**ADDENDUM**  
**MEETING OF THE PLANNING COMMITTEE**  
**WEDNESDAY 25<sup>th</sup> November 2020**

**PLANNING APPLICATION: 20/00861/F –Little Thorns, London Road, Redhill**

**PLANNING APPLICATION: 20/01540/F – Shrewsbury Court**

**PLANNING APPLICATION: 19/02559/F – THE EPIPHANY HOUSE MANSFIELD DRIVE MERSTHAM**

Main car park/entrance layout

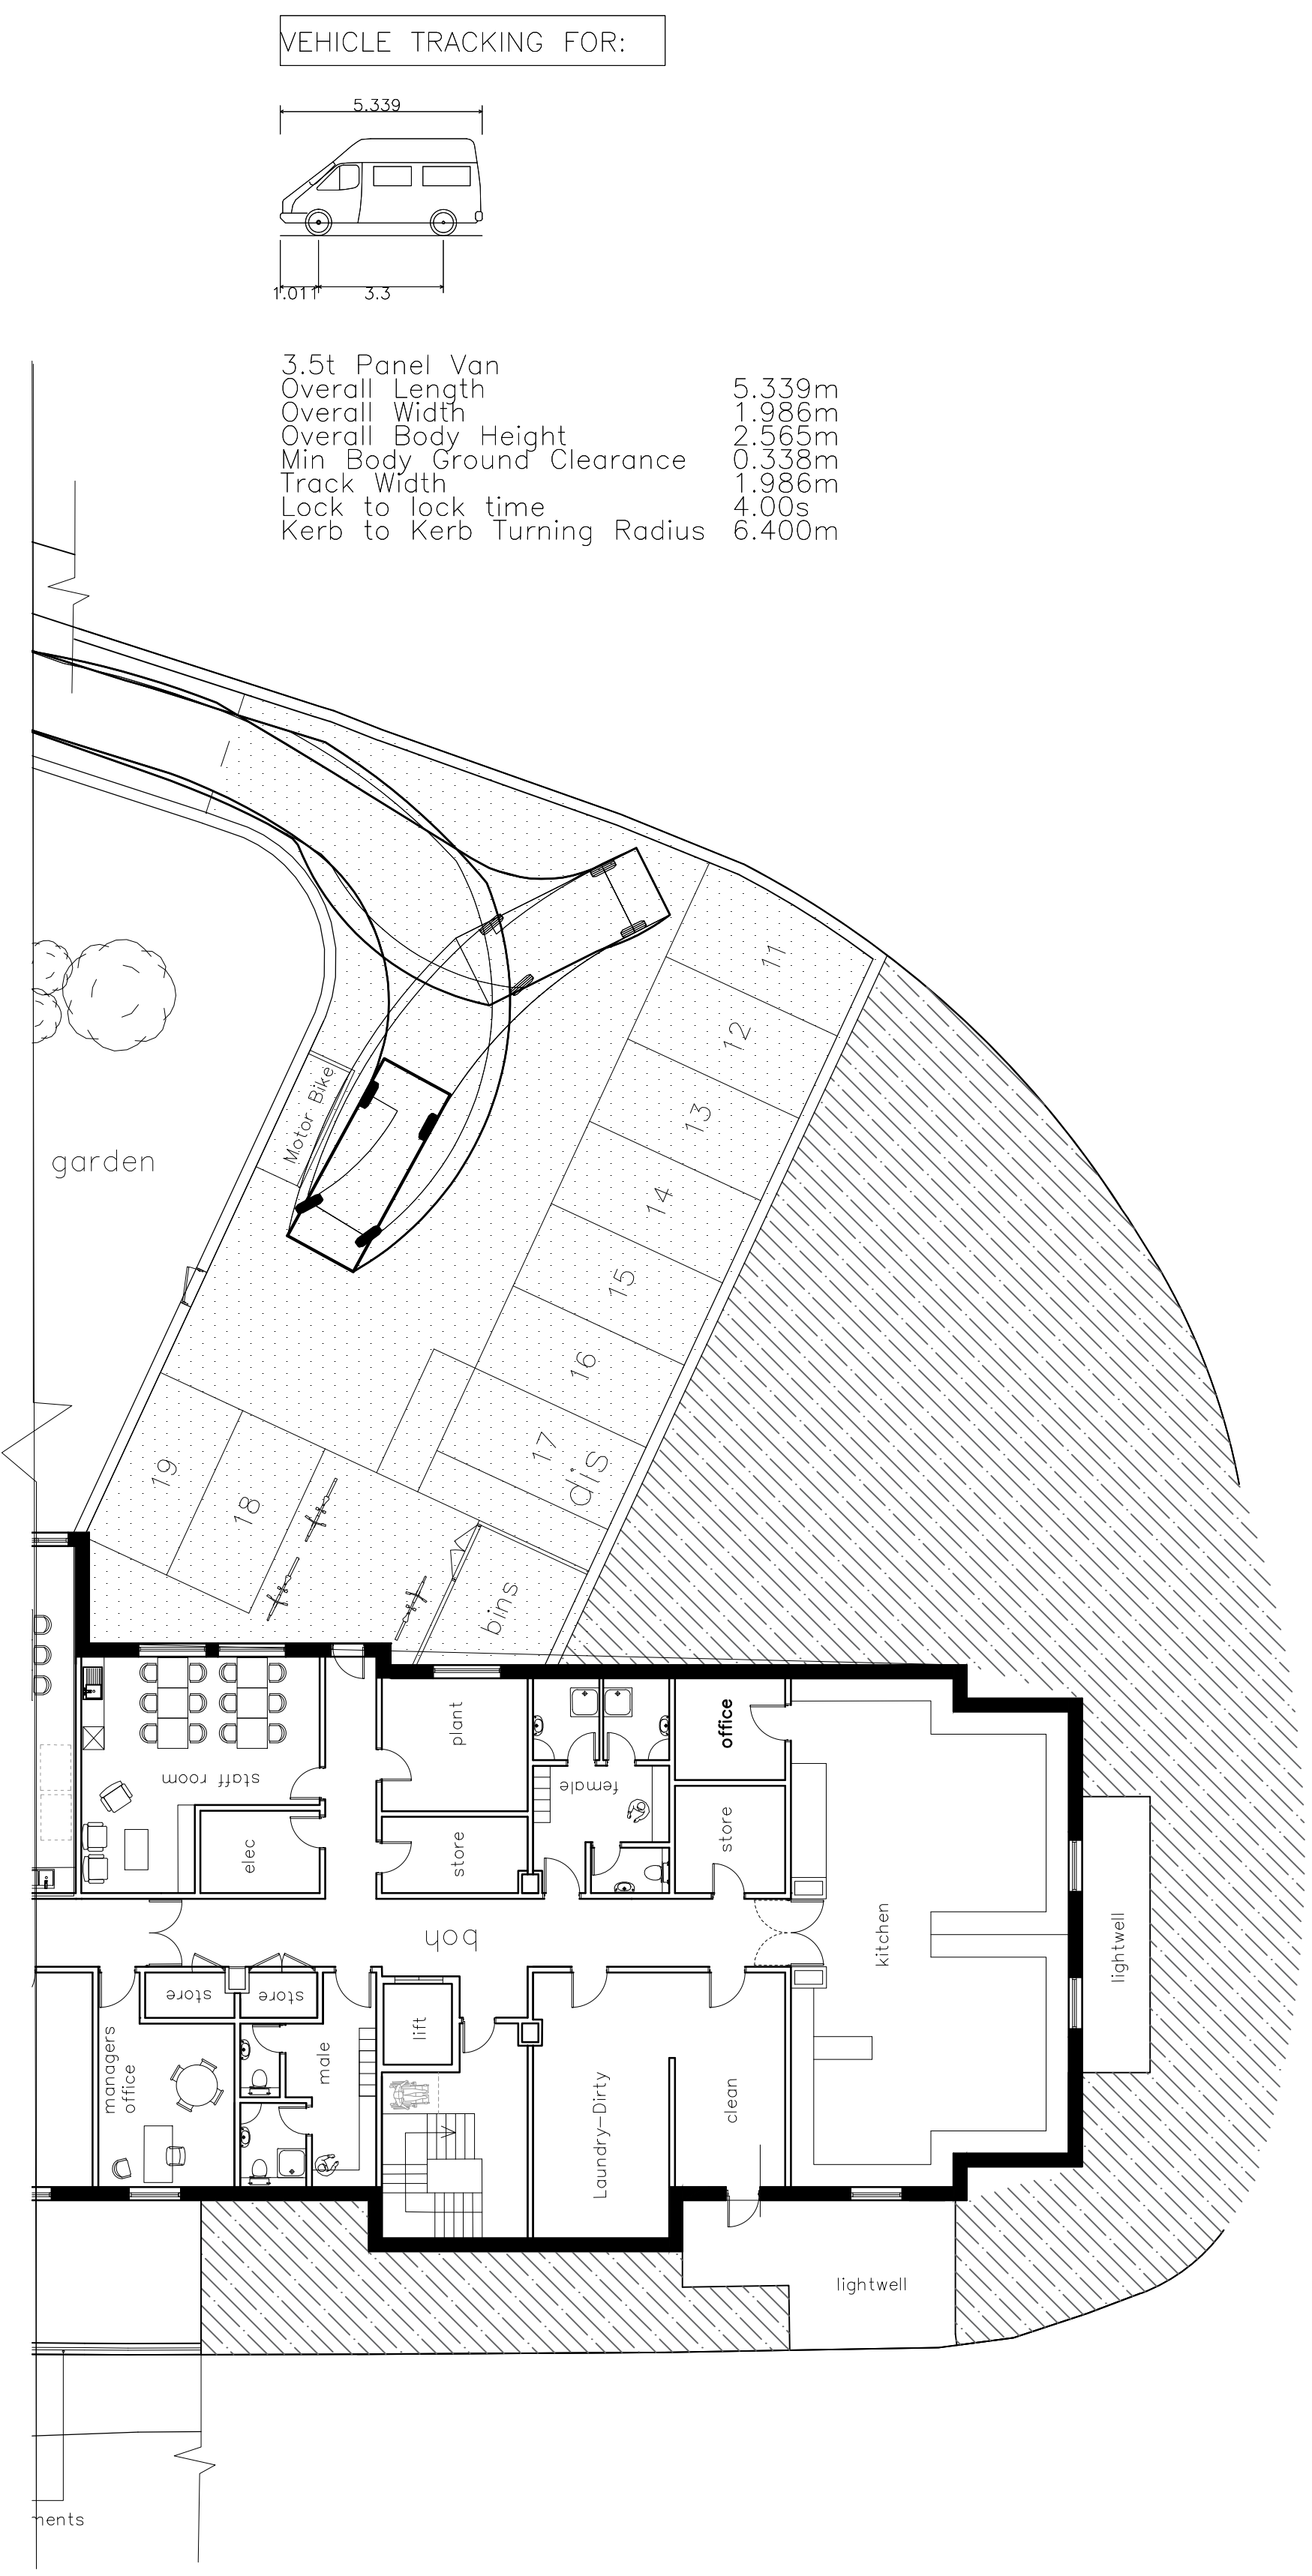
A plan which helps show the undercroft parking area, beneath the above garden areas is included at **Appendix C**

Appendix E

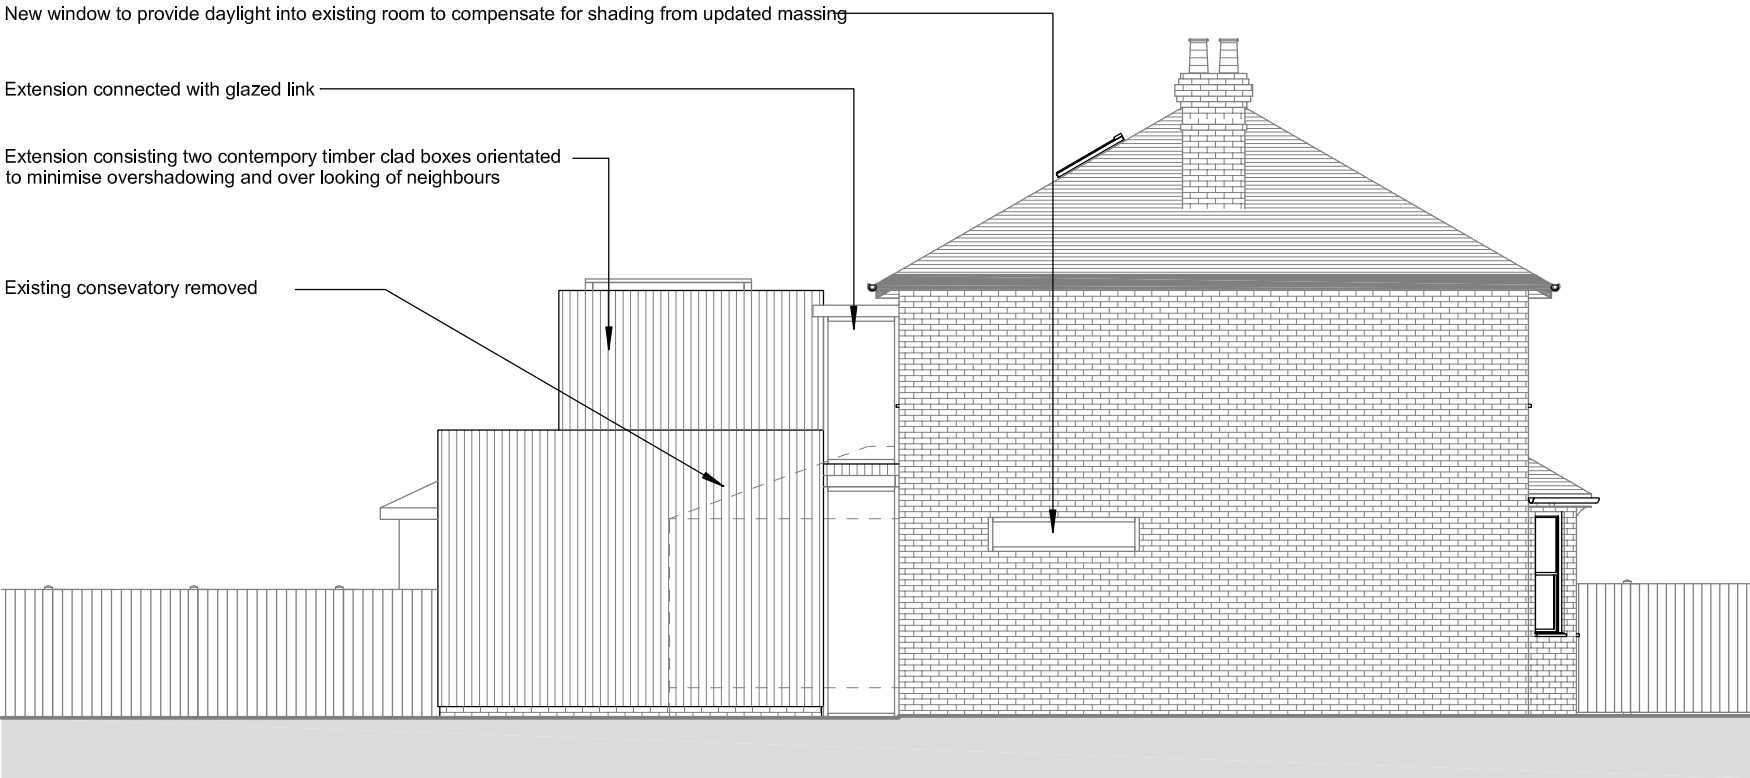
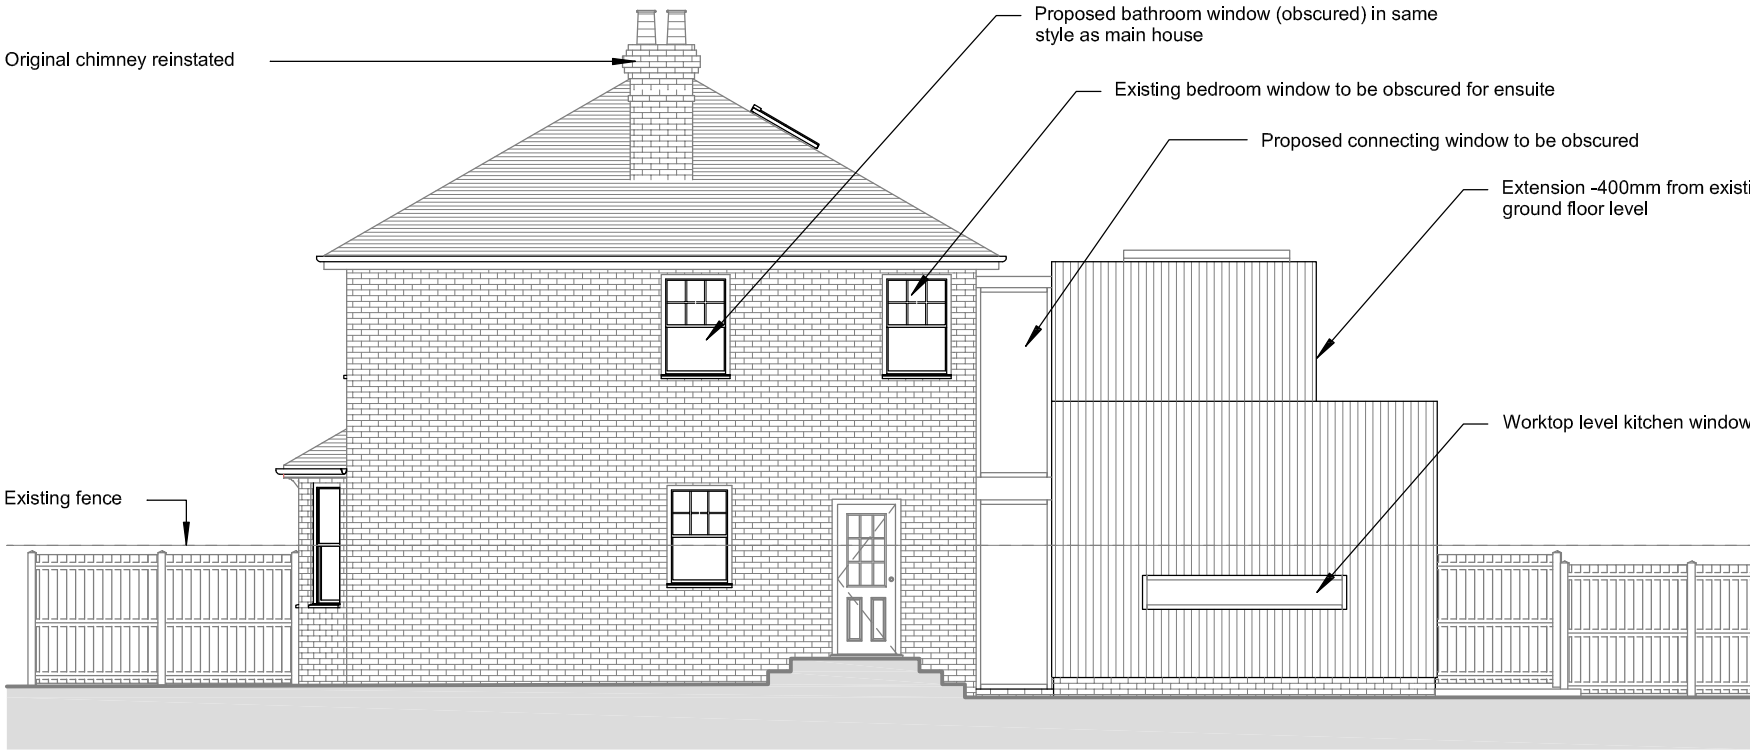
A corrected elevation plan has been submitted (see appendix D) which provides the appropriate definition of ground and first floors on the side elevations and so condition 1 has been reworded as follows:

1. The development hereby permitted shall be carried out in accordance with the following approved plans.

<b>Plan Type</b>	<b>Reference</b>	<b>Version</b>	<b>Date Received</b>
Floor Plan	1100	P6	28.10.2020
Elevation Plan	2100	P6	25.11.2020
Existing Plans	1001	P5	28.08.2020
Floor Plan	1900	P1	28.08.2020
Proposed Plans	2701	P3	28.08.2020
Elevation Plan	2900	P1	28.08.2020
Section Plan	3100	P5	28.08.2020
Roof Plan	1110	P3	28.08.2020
